WATERBURY FILING NO. 1
CONSTRUCTION SET
COVER SHEET
DESIGNED BY QNA
DRAWN BY QNA
CHECKED BY
H-SCALE AS SHOWN
V-SCALE N/A
JOB NO. 2356.00
DATE ISSUED 10/4/24
SHEET NO. 1 OF 52

WATERBURY FILING NO. 1

CONSTRUCTION SET
SIGNING & STRIPING
SAYBROOK & ROUNDABOUT

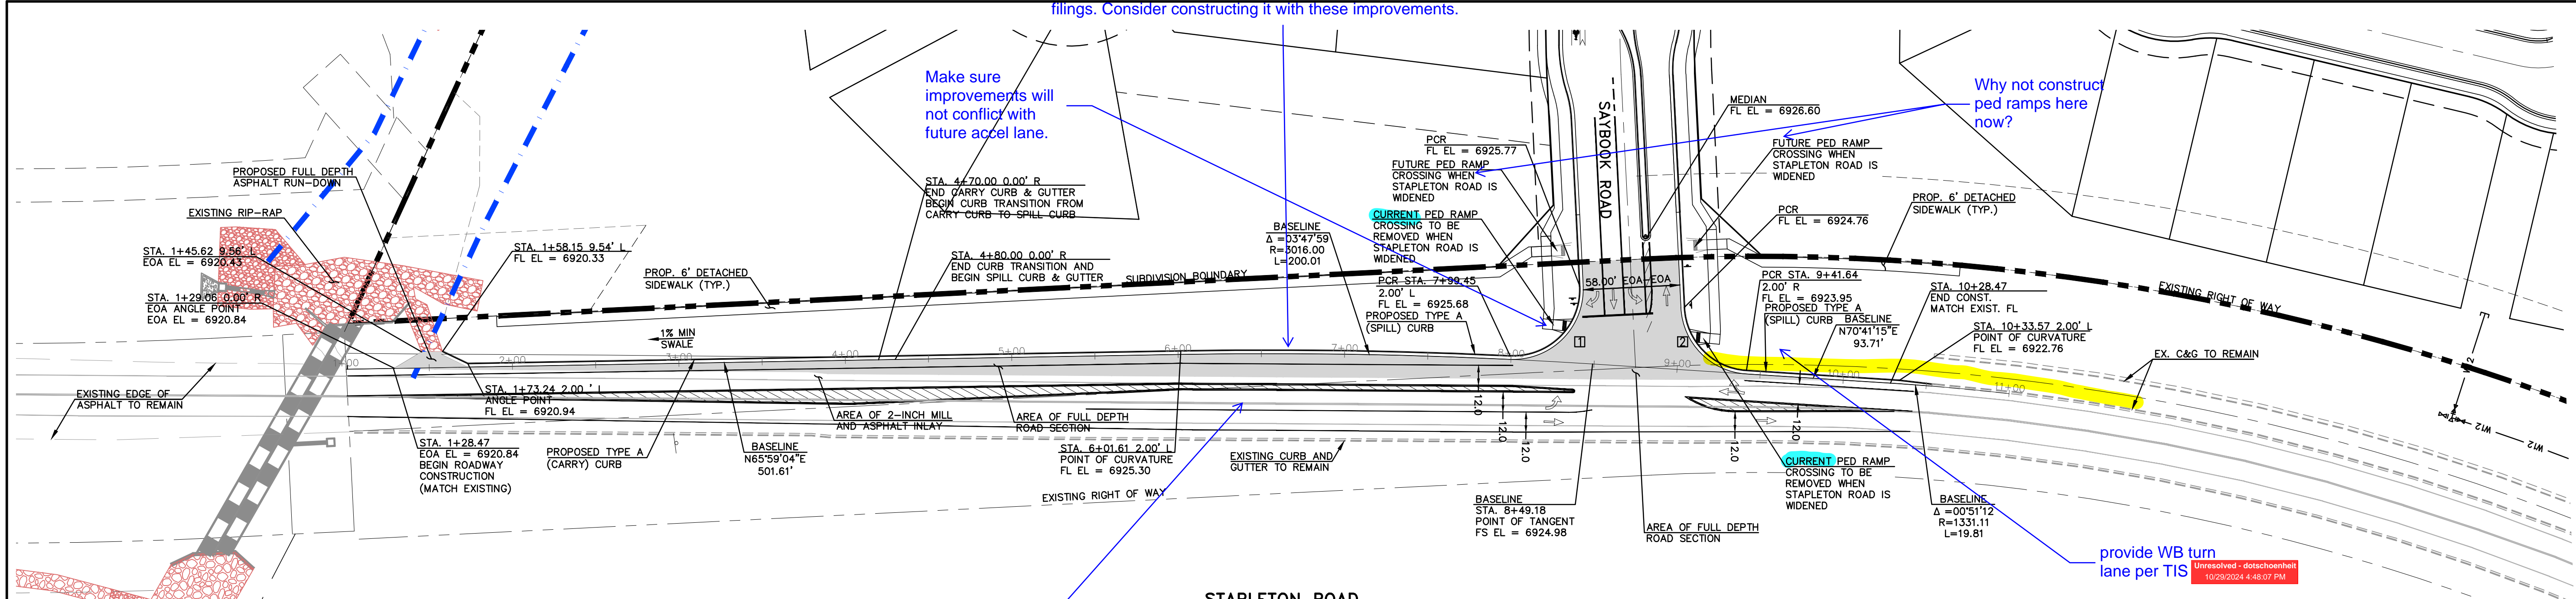
Add note for letter and sign size at Stapleton intersection.

POND 1 CONCRETE MICROPOOL PHASE 1
SCALE: N.T.S.

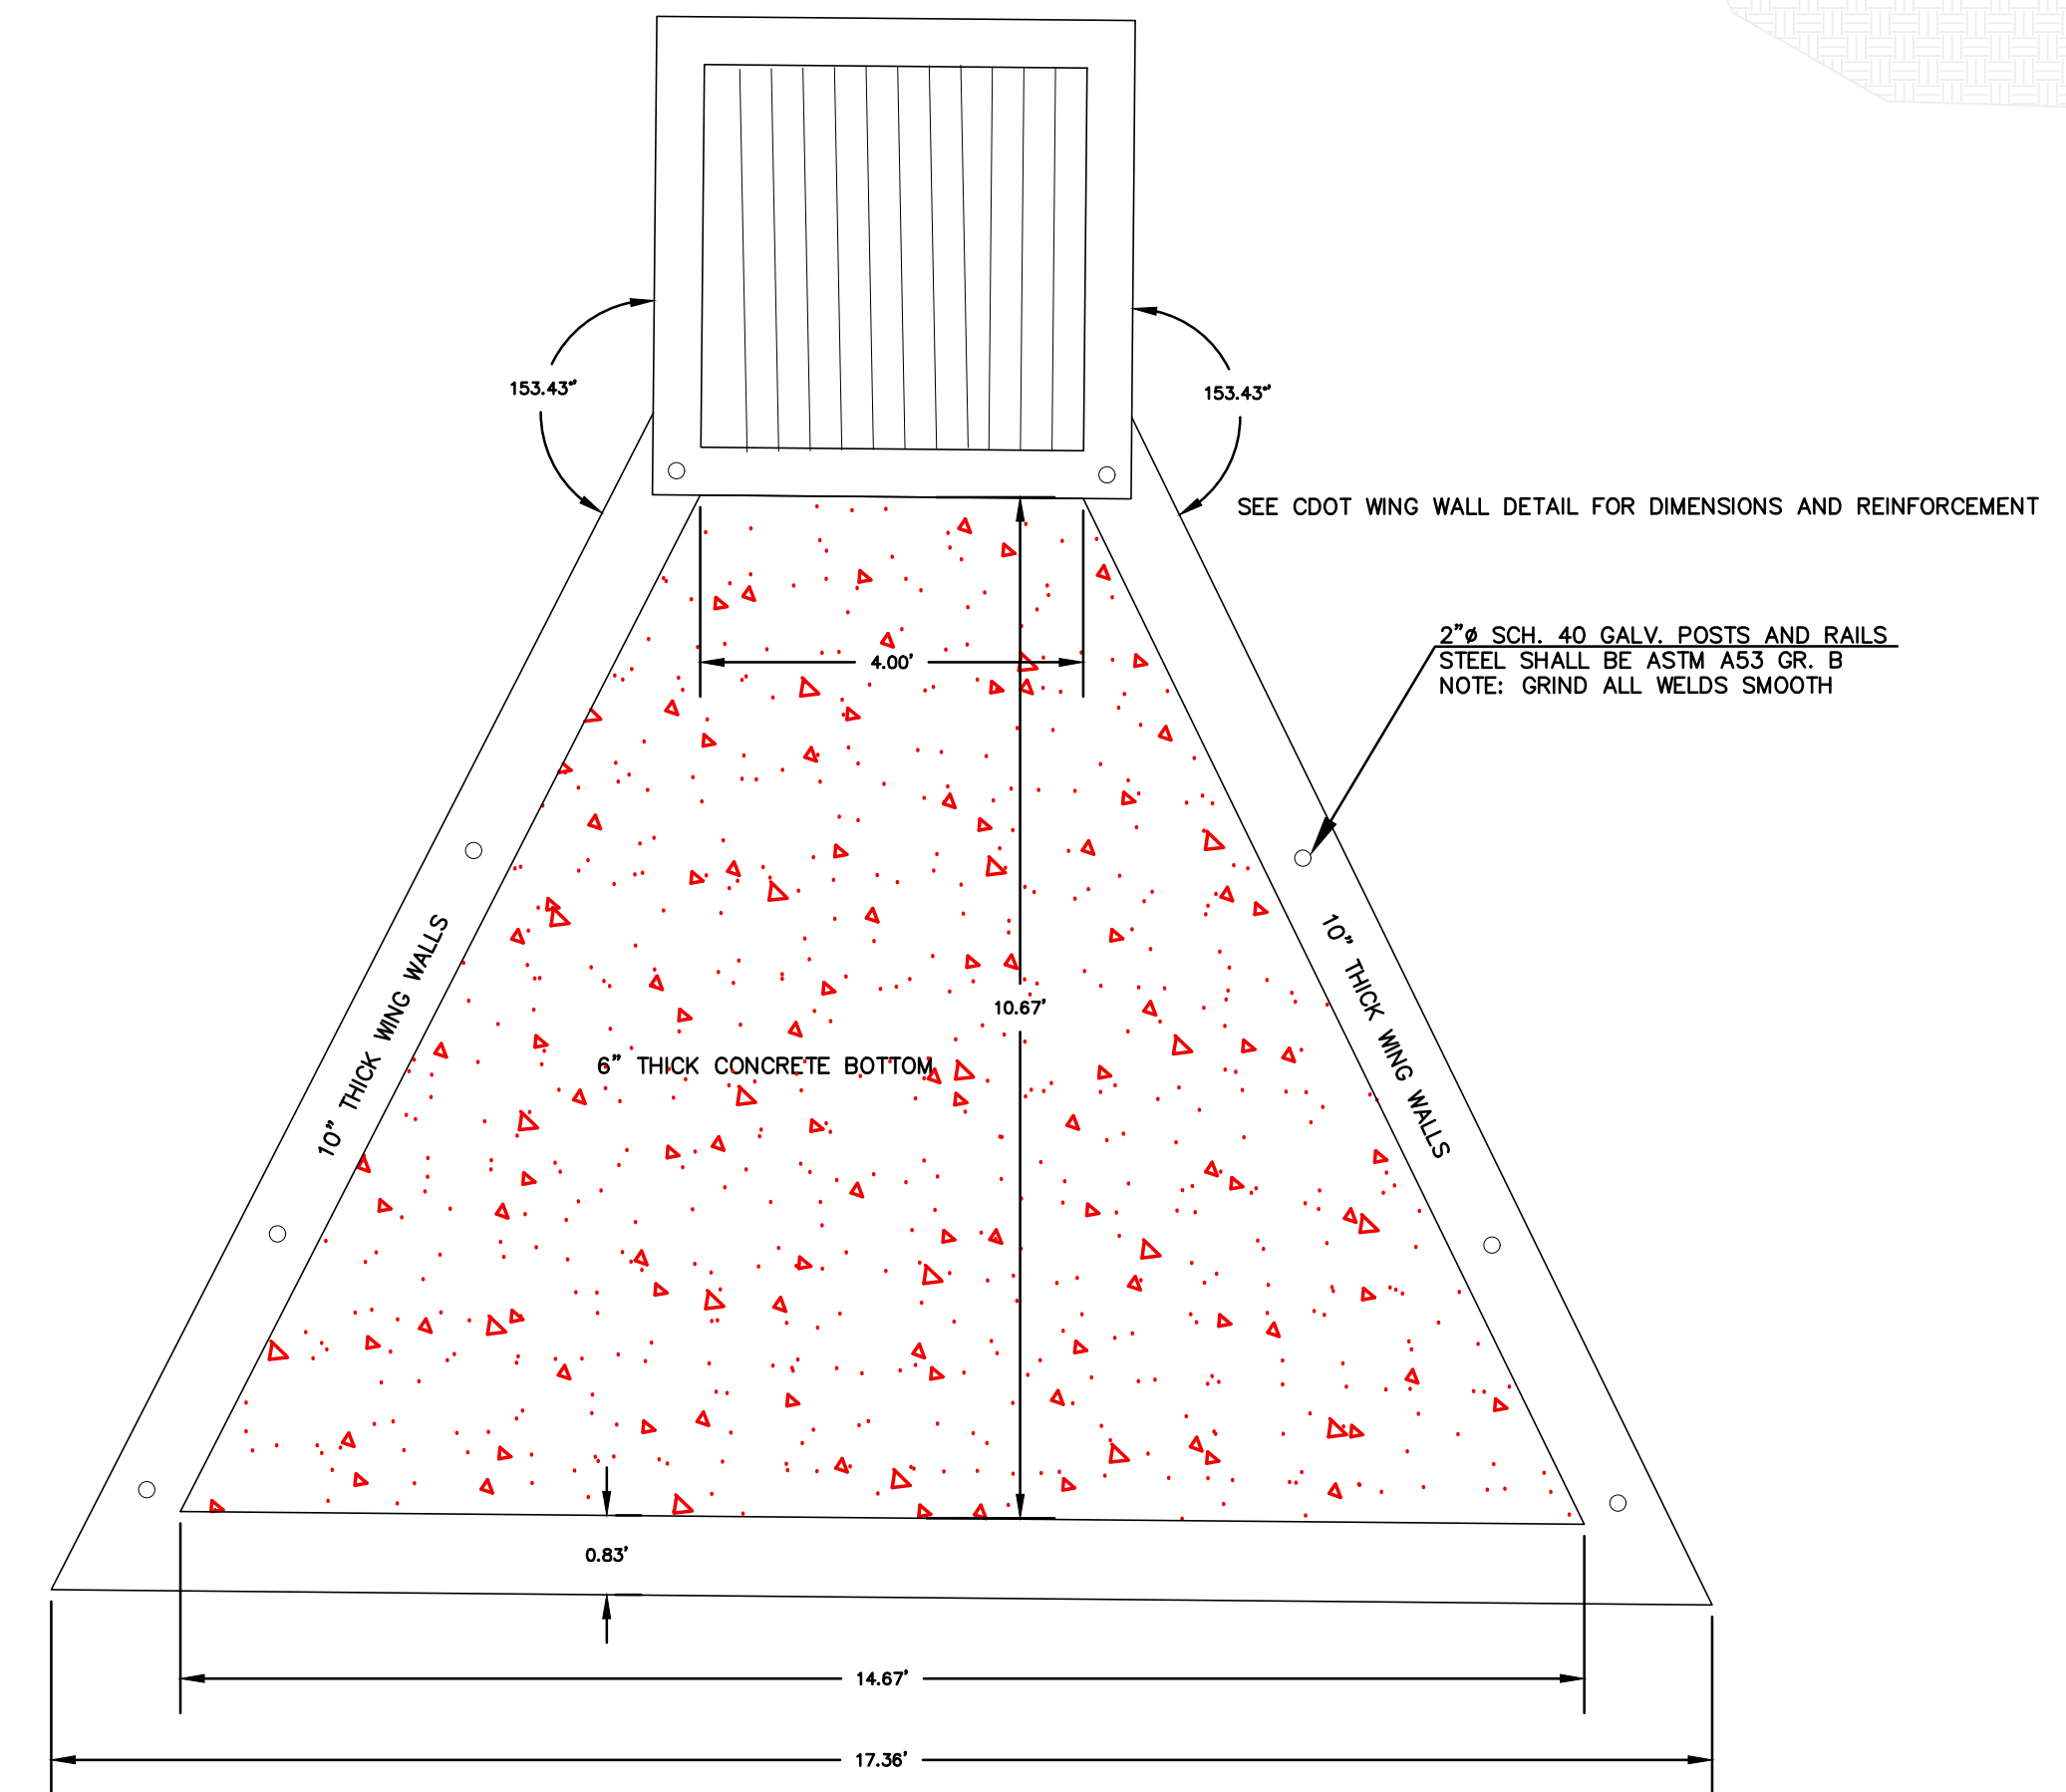
Please select which type of trash rack is proposed to be used and provide the specific specifications for the one selected as needed.
